From:
Sent: 15 February 2025 18:47
To: DC Admin
Subject: 2025 90160 Dunkirk Car park - Impairment or Distraction to Highway users

2025 90160 Dunkirk Car park - Impairment or Distraction to Highway users

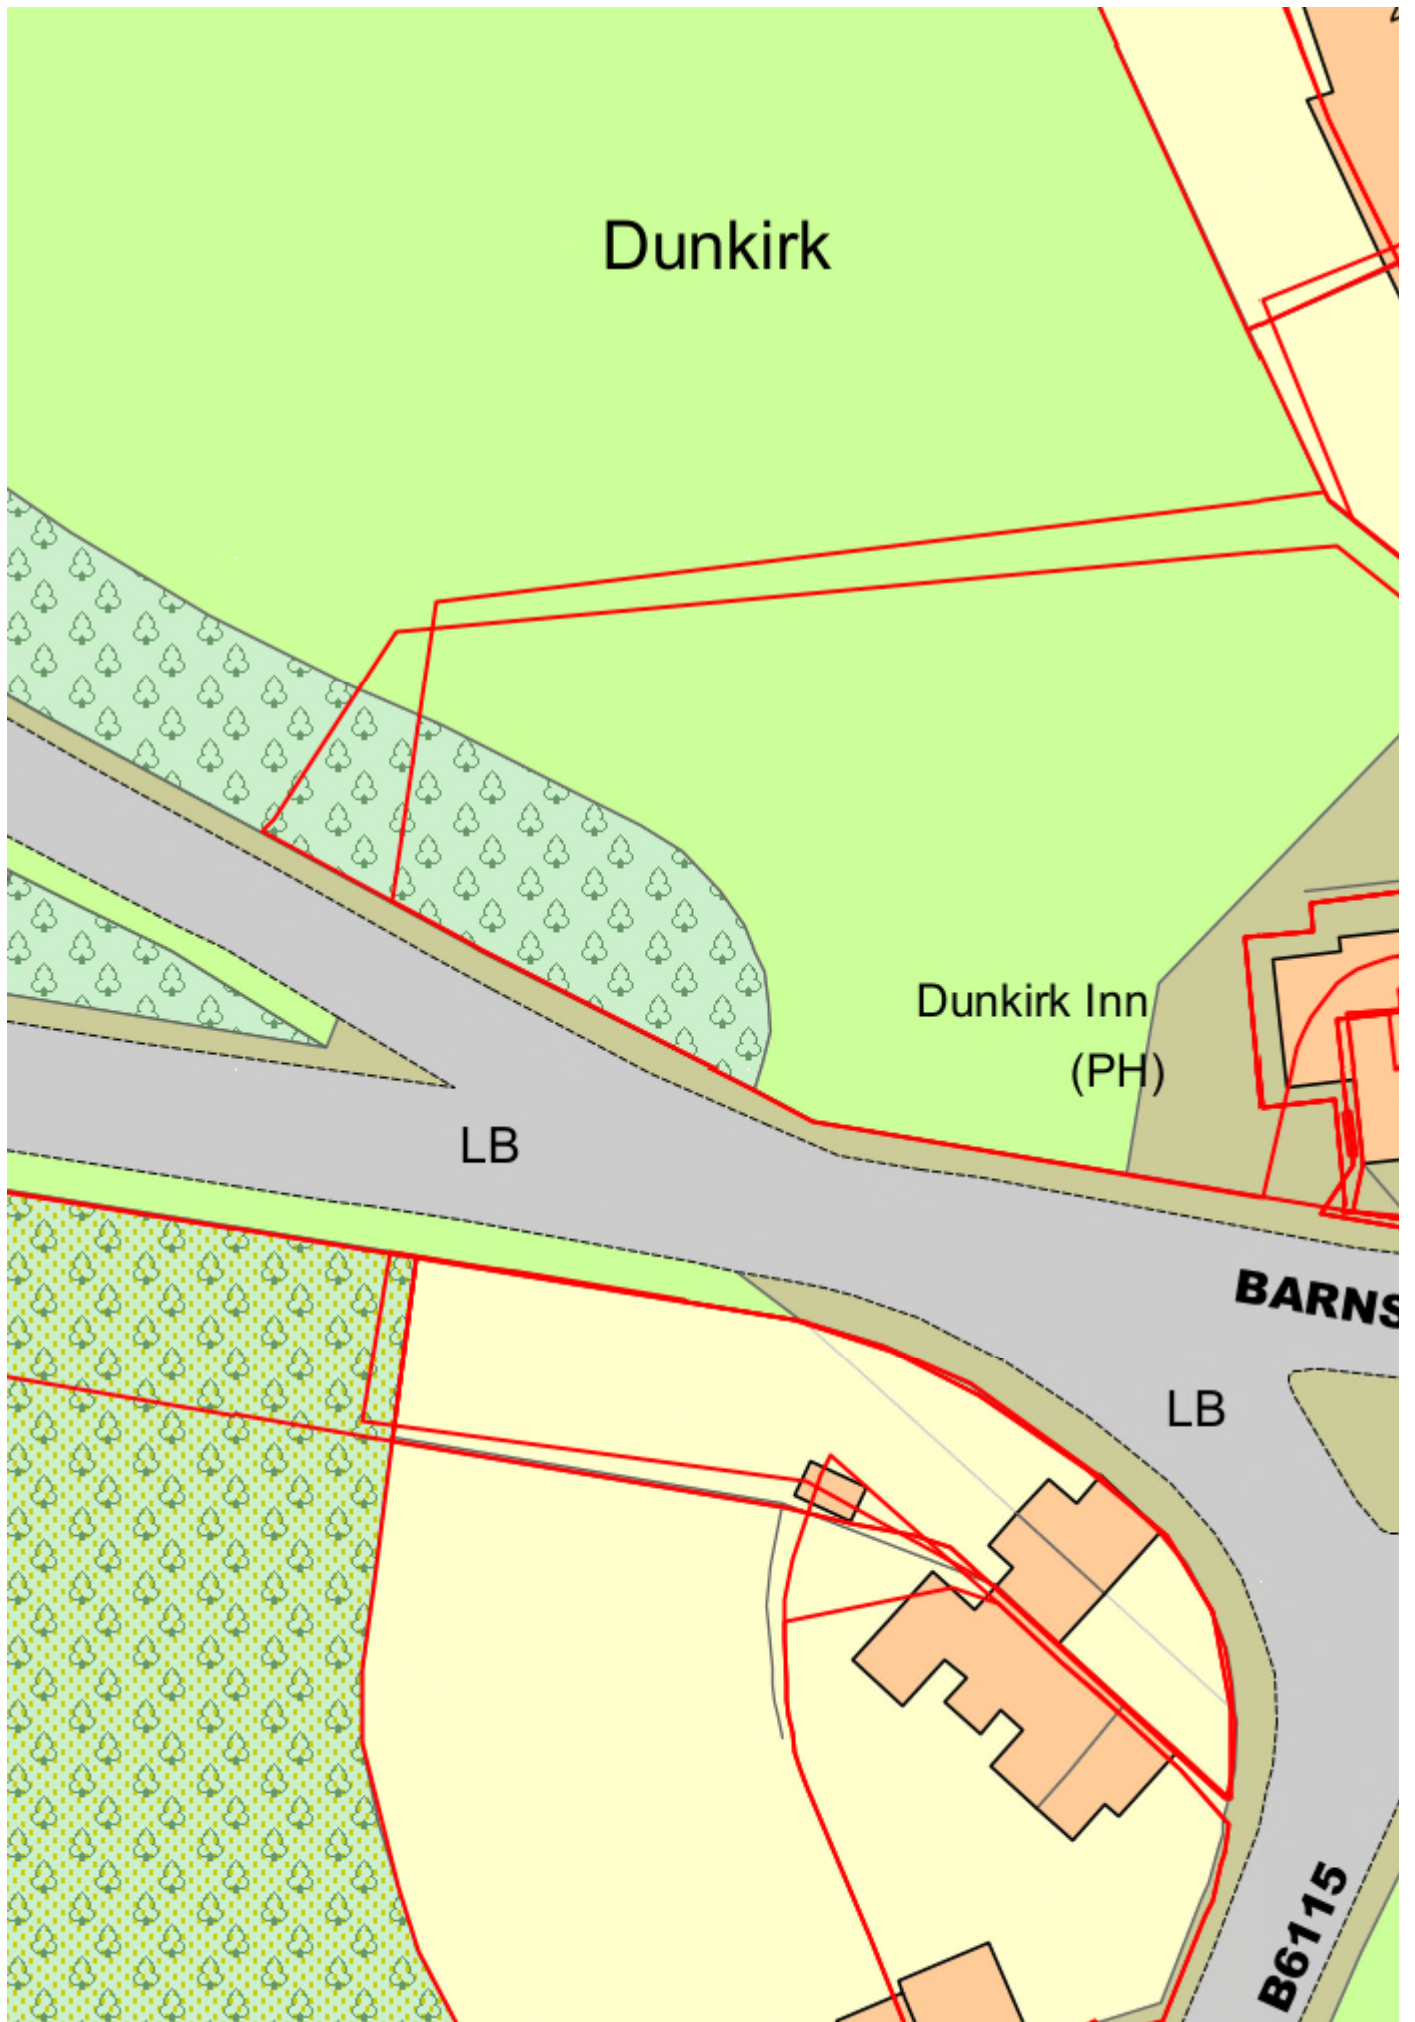
Over the last weeks, I have experienced being blinded by the lights from vehicles in the car park

- Cars just being static parked with dipped beams on
- Cars being static parked with their main beams on
- Cars being static awaiting in or around the car park with lights on
- Cars moving and sweeping around the car park with lights on
- Users of the car park are unaware of the effect on oncoming drivers
- Many cars have auto lights on and are so positioned that the car does not

This has the effect of visually blinding the drivers using the highway,
I have been subjected to this random effect of lights from the car park on several occasions these dark evenings

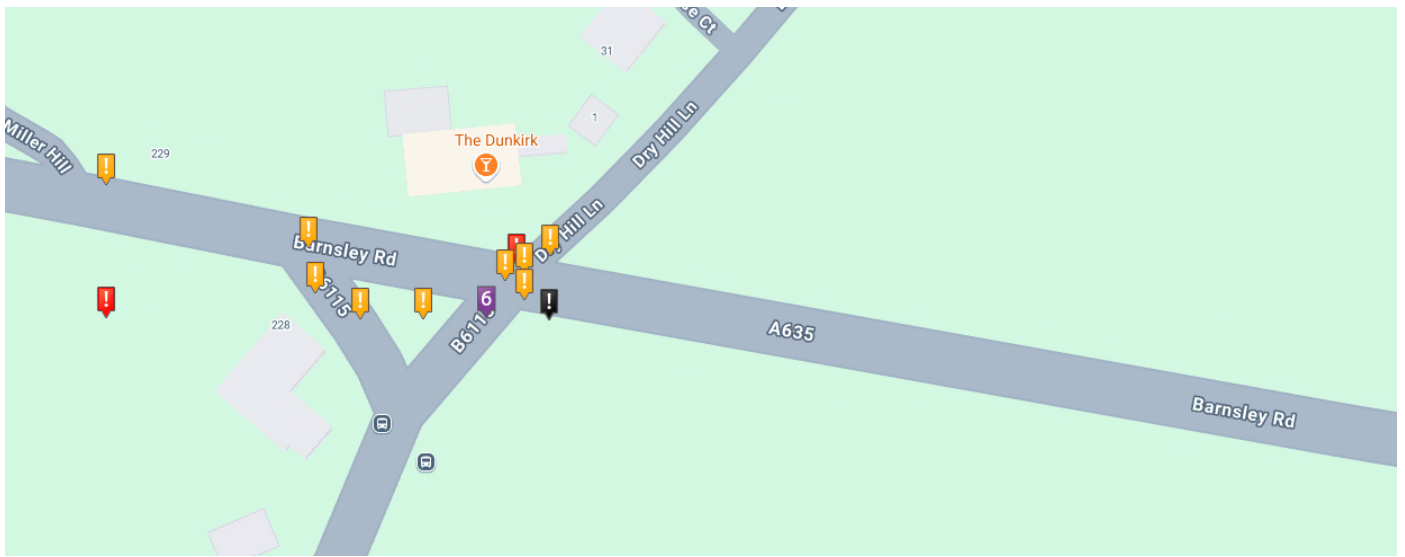
The dry-stone perimeter walling that was there have been removed

The surface datum of the car park varies and goes over 196 m
Vehicles travelling along the A635 are at datum of 188 m or less and are blinded by the vehicles using the car park

The users of the B6115; vehicles wishing to cross the A635 are also subject to being sight impaired by vehicles headlights within the car park

There is an objection to the highway safety matter, caused by no suitable car park perimeter, to prevent lights affecting highway users
